3 | Drainage Report Addendum (February 2020) Preliminary Drainage Report (February 2019)

Fort Bragg ADA

#### Subject: Addendum to Preliminary Drainage Recommendations

Subject: PRELIMINARY DRAINAGE REPORT

DRAINAGE RECOMMENDATIONS
ON
DESIGN LAYOUT

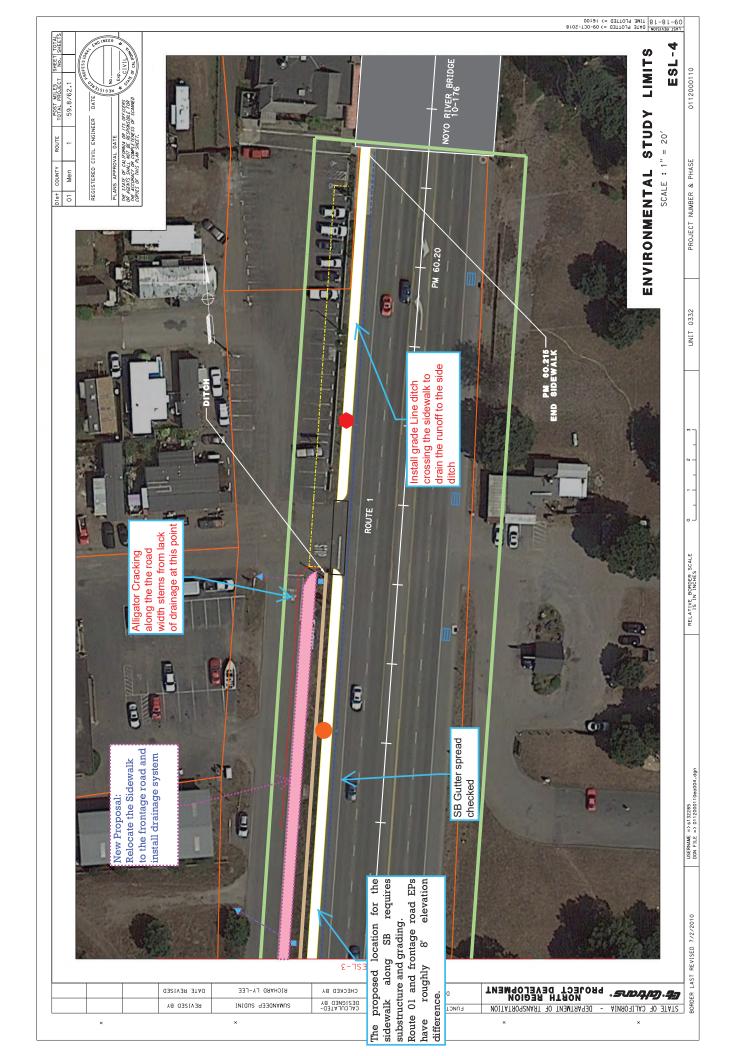
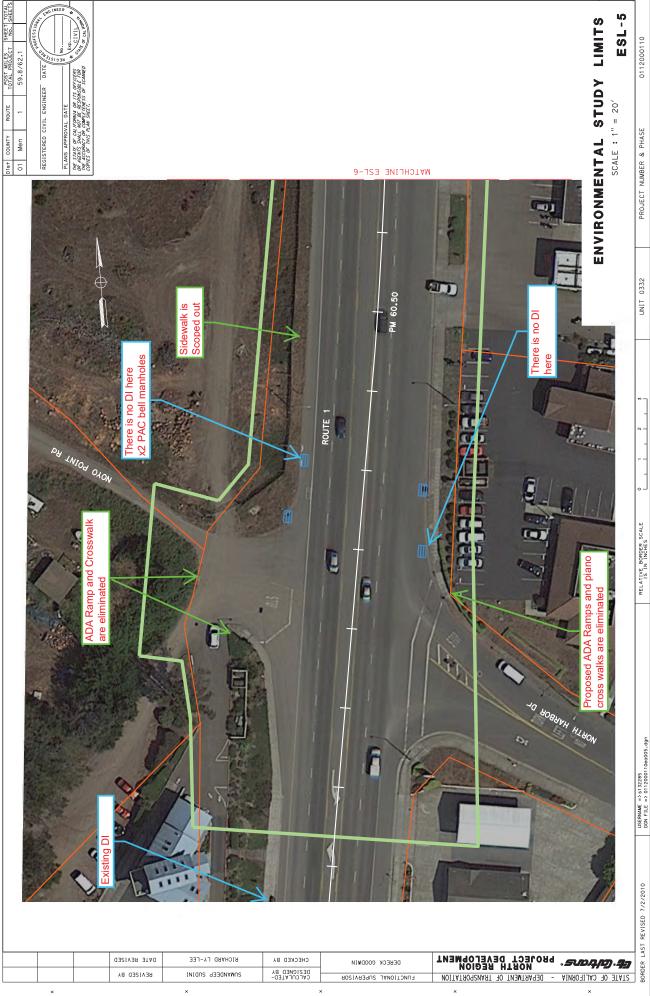
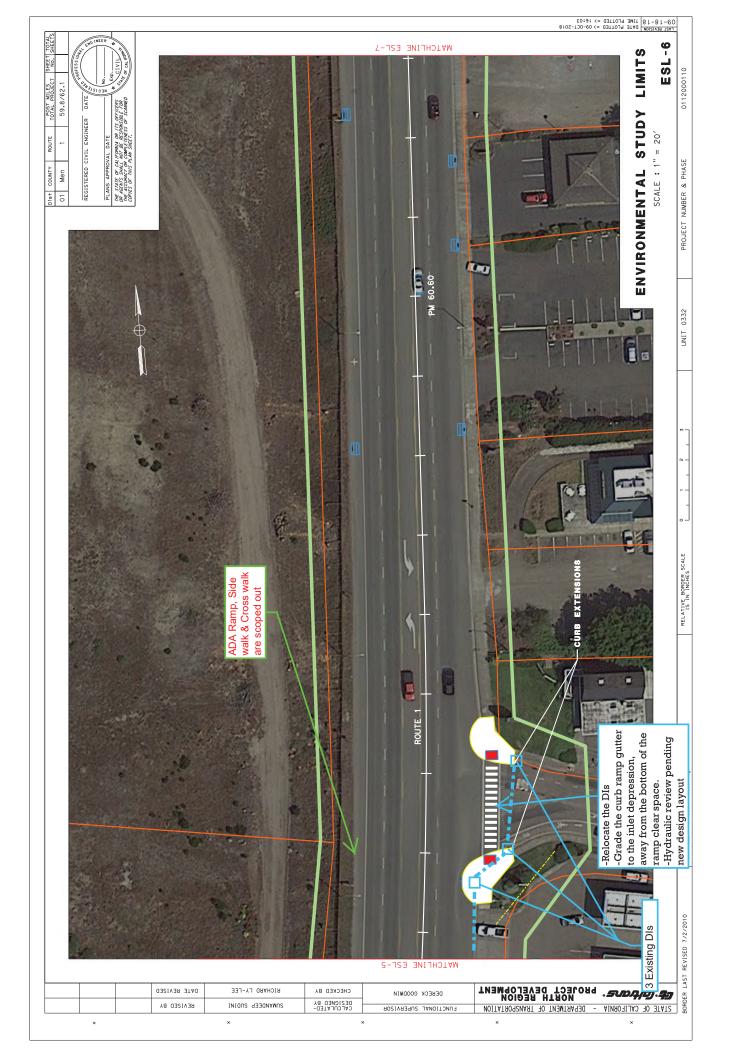
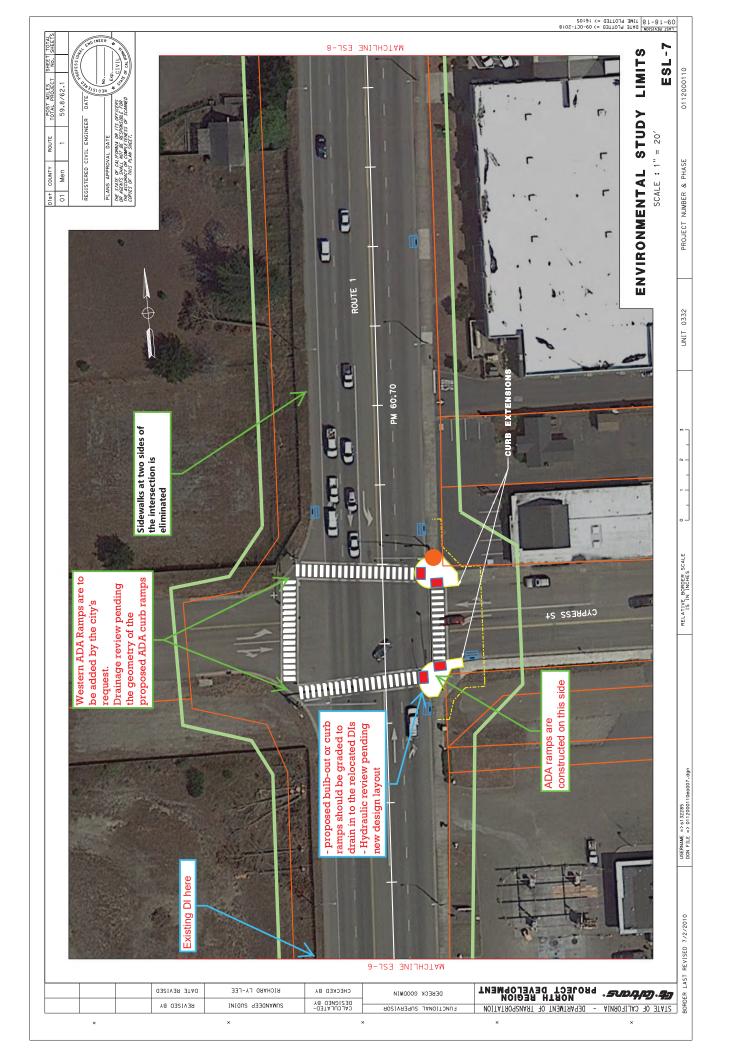
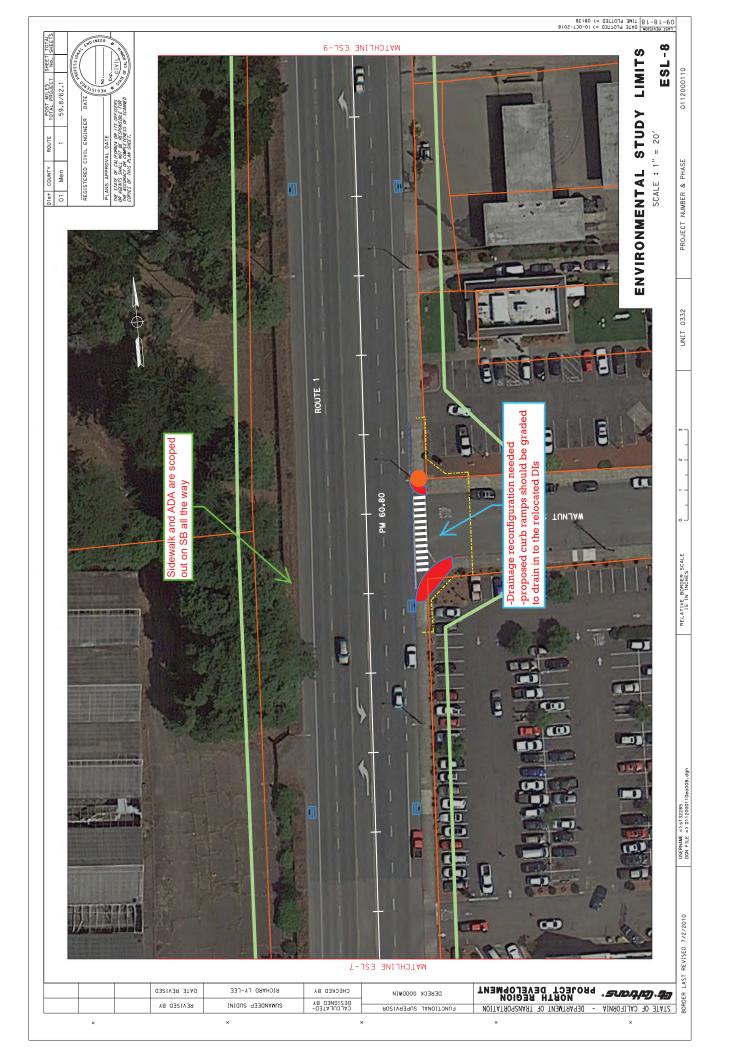
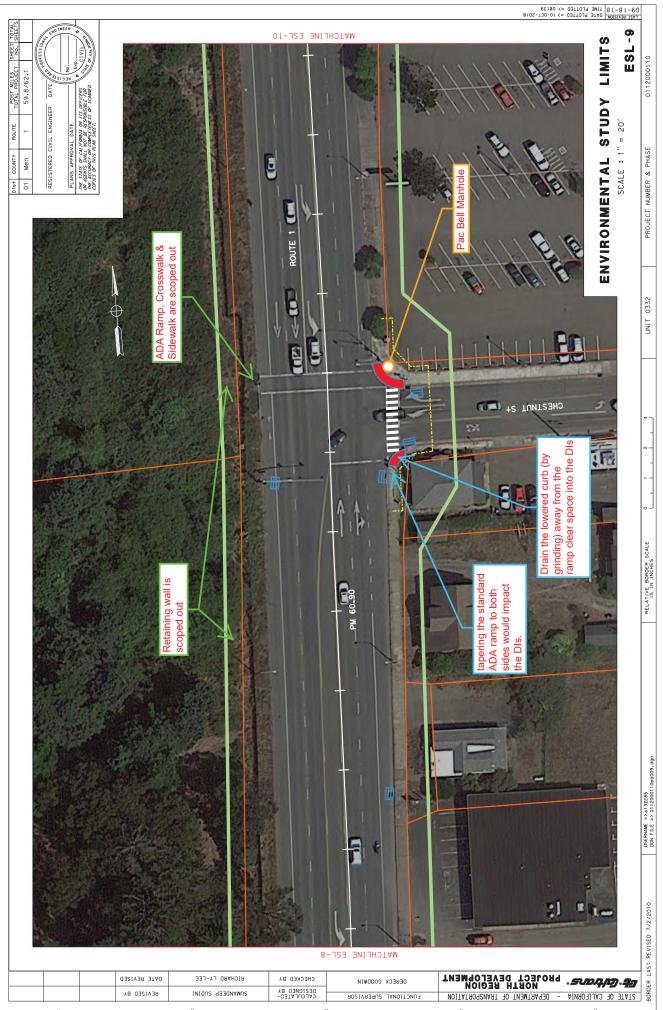
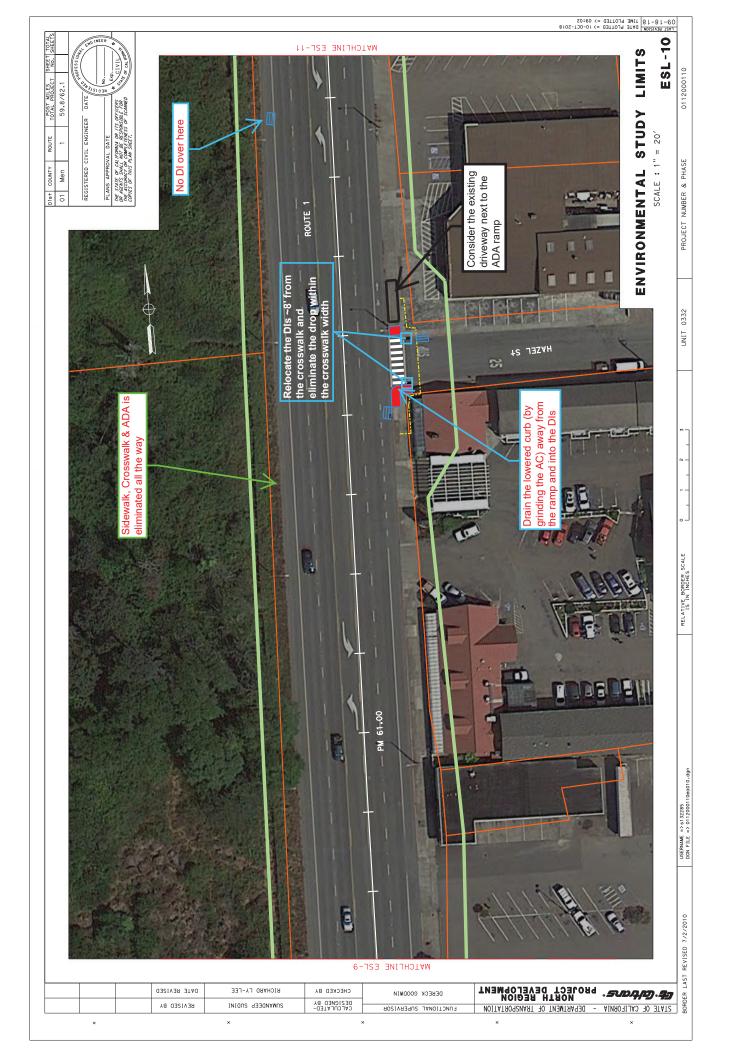
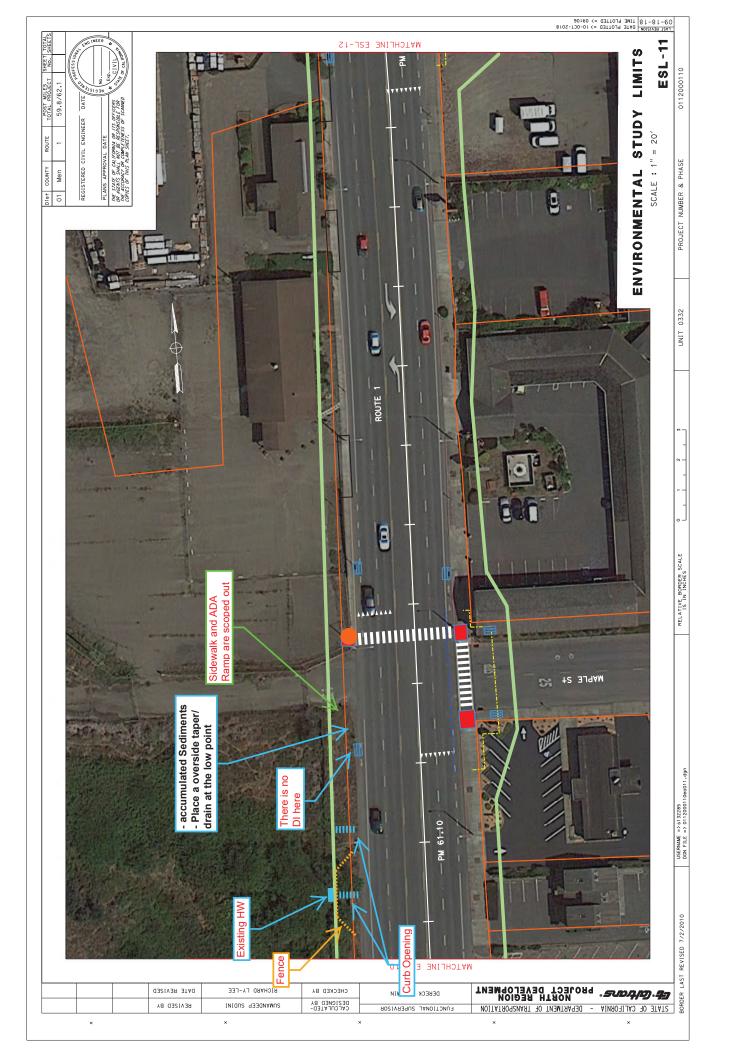
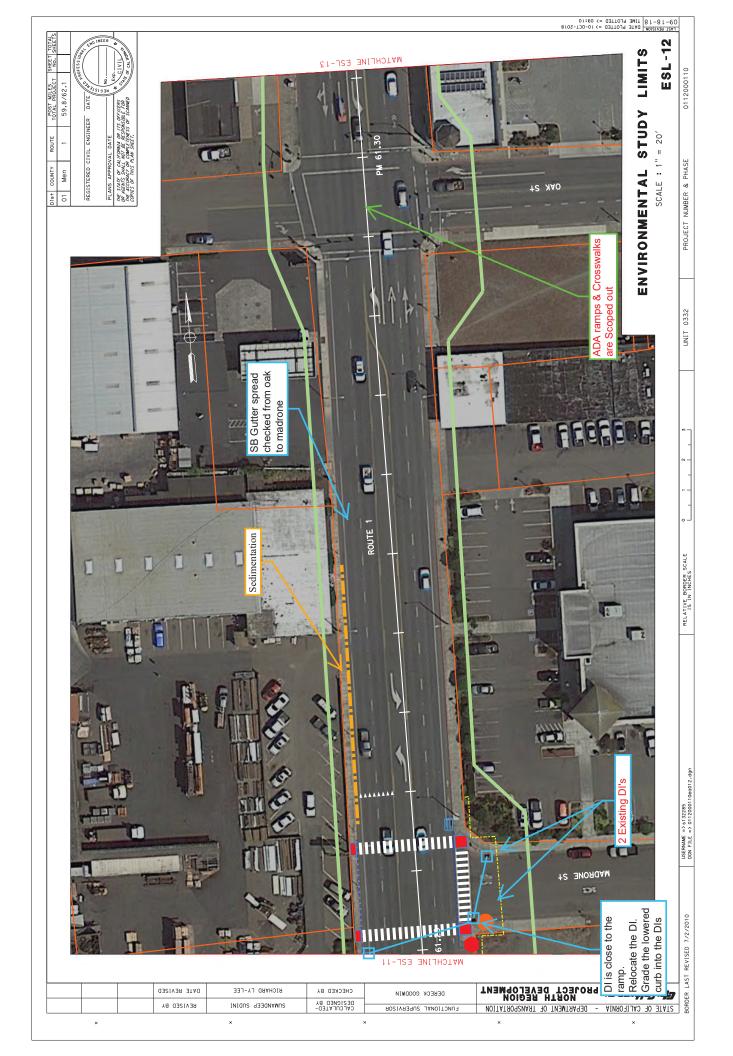
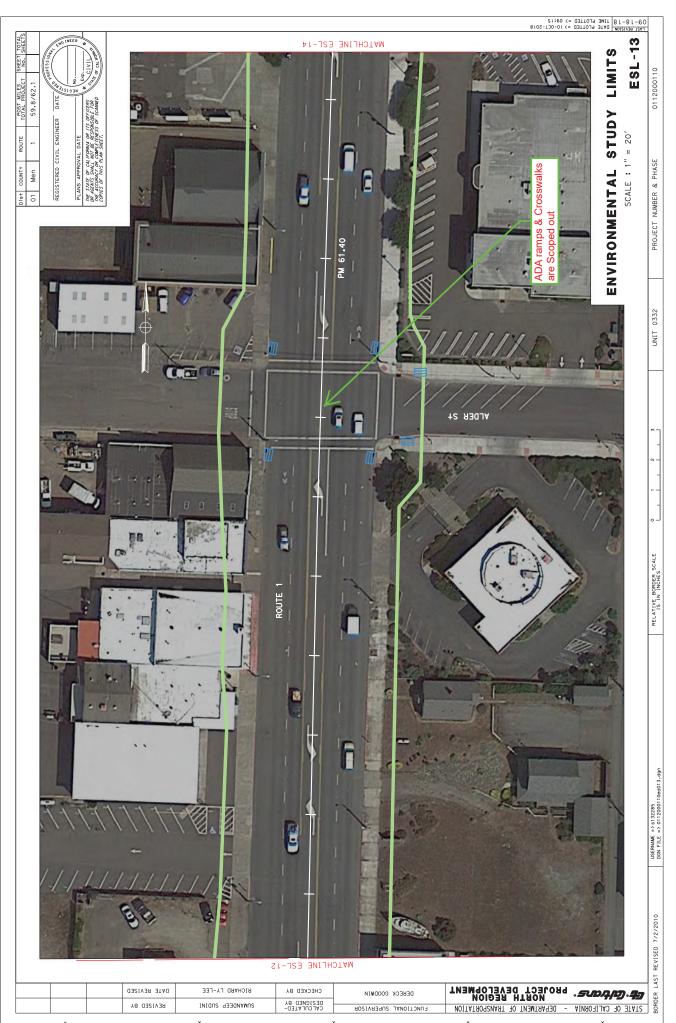
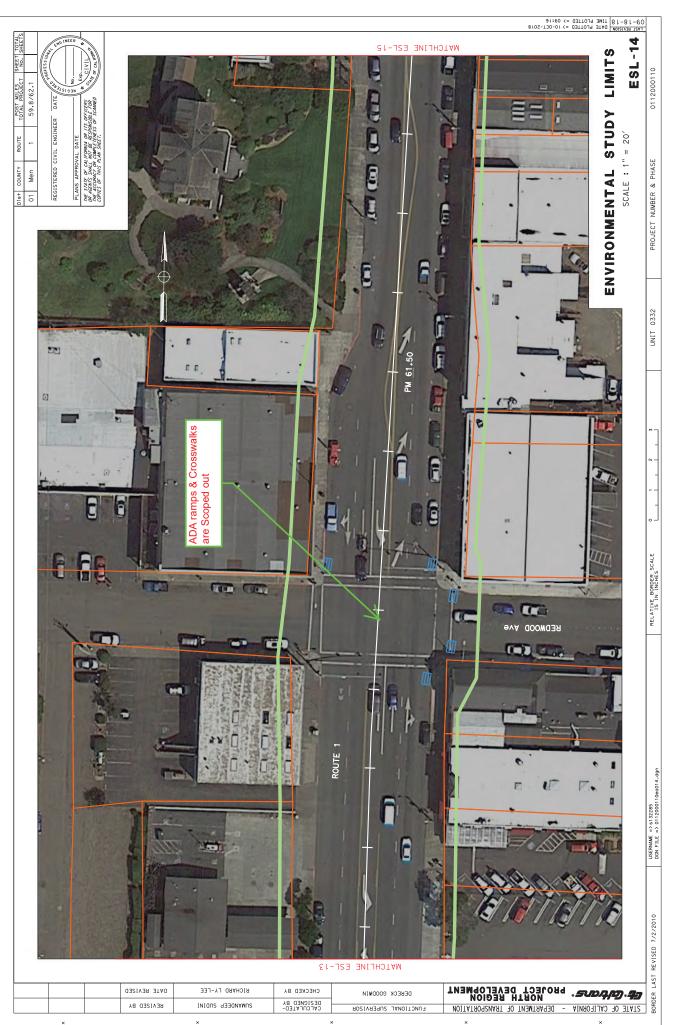
- ➤ Please review the attached layouts including comments and recommendations pertaining to drainage in attachment-3.
- Work location matrix prepared during the previous phase of this project has been updated and attached to this document in attachment-5.

Due to the existing sedimentation and debris around the inlets, along the side curbs and on curb ramps, gutter spread analysis were performed at specific locations (as delineated and commented on the attached layout) and the calculation results are in attachment-2 of this document.
